Model: Russian-C3		Date: 22-Jan-04	No.: MB089001
Modified Article: Parts Catalog Correction		Prepared by: Y. Ohtani	
From: 1st Tech. Support Sec. Service Support Dept.			
Reason for Modification:	☒ Parts catalog correction ☐ To facilitate assembly ☐ Part standardization	☐ Vendor change ☐ To improve reliability ☐ Other	☐ To meet standards ()

Please apply the following changes to your Parts Catalogs.

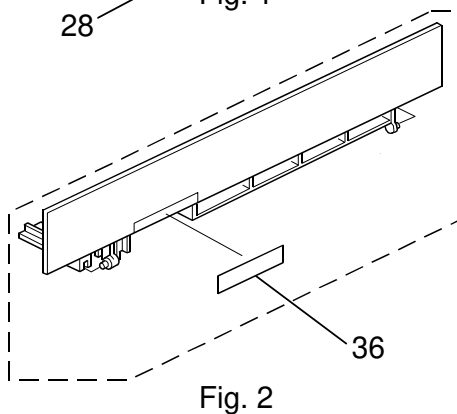
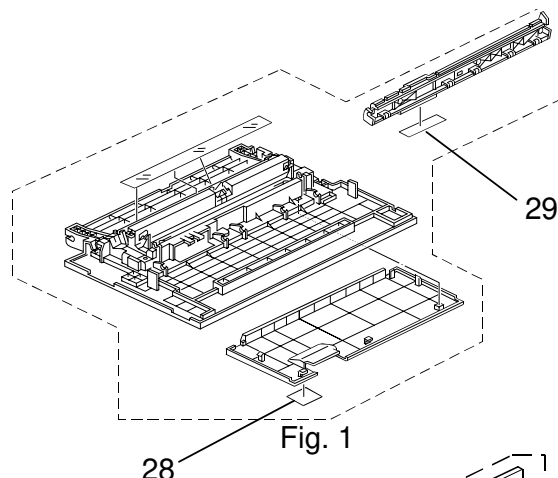
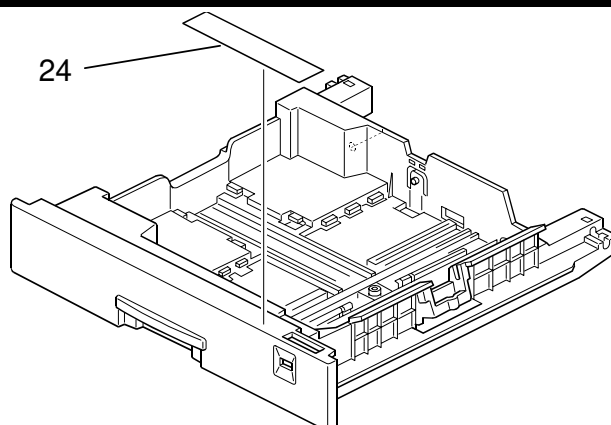
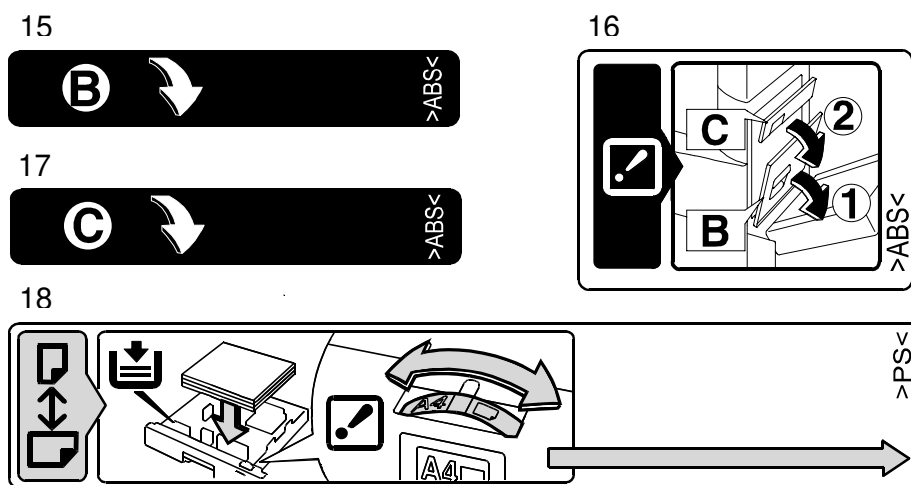
These decals were added to ensure correct user operation of paper size setting and removing paper jams:

Old part number	New part number	Description	Q'ty	Int	Page	Index	Note
	B0904460	Decal – Jam Removal – Right Cover	0–1		25	28	Fig 1
					81	16	Fig 4
	B0904461	Decal – B	0–1		25	29	Fig 1
					81	15	Fig 4
	B0904462	Decal – C	0–1		43	24	Fig 2
					81	17	Fig 4
	B0902961	Decal – Paper Size Select	0–1		37	36	Fig 3
					81	18	Fig 4

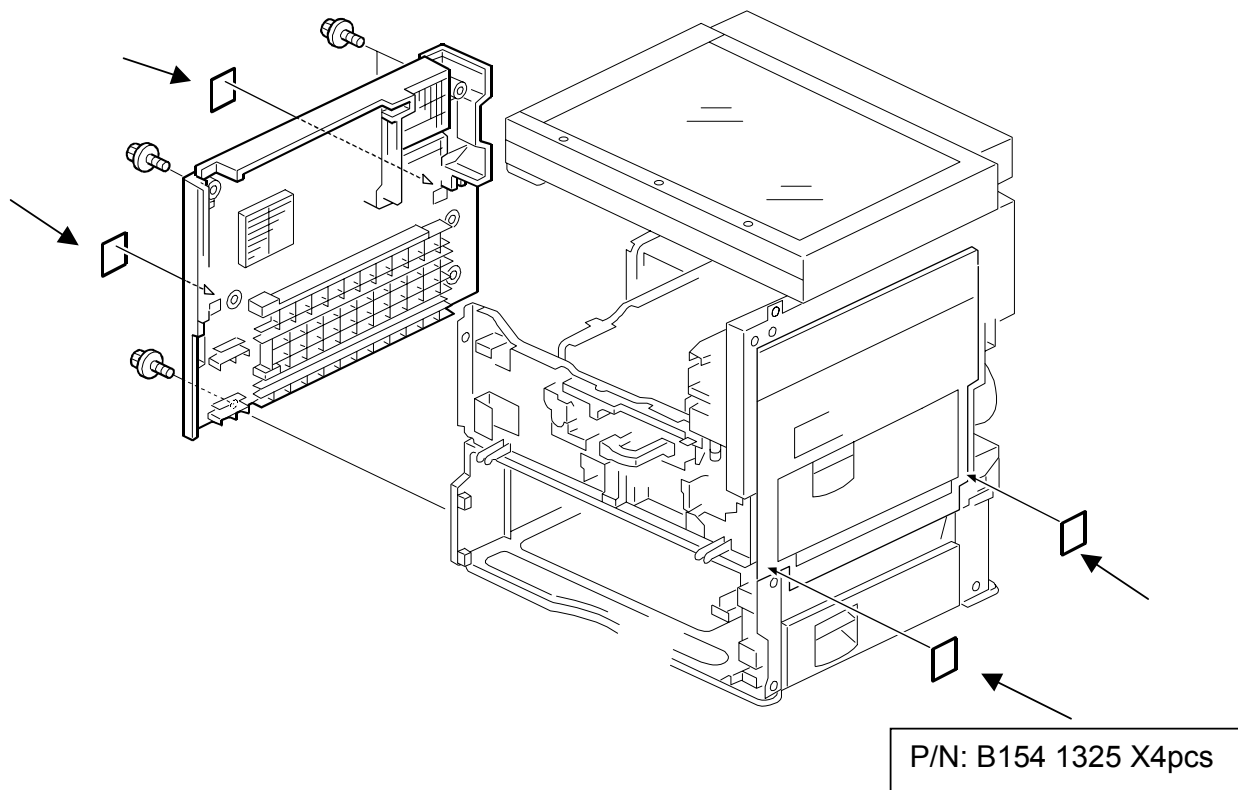
To prevent the handles from coming out of the machine, protection sheets have been added.

Old part number	New part number	Description	Q'ty	Int	Page	Index	Note
	B1541325	Protection Sheet - Handle	0-4		11	36
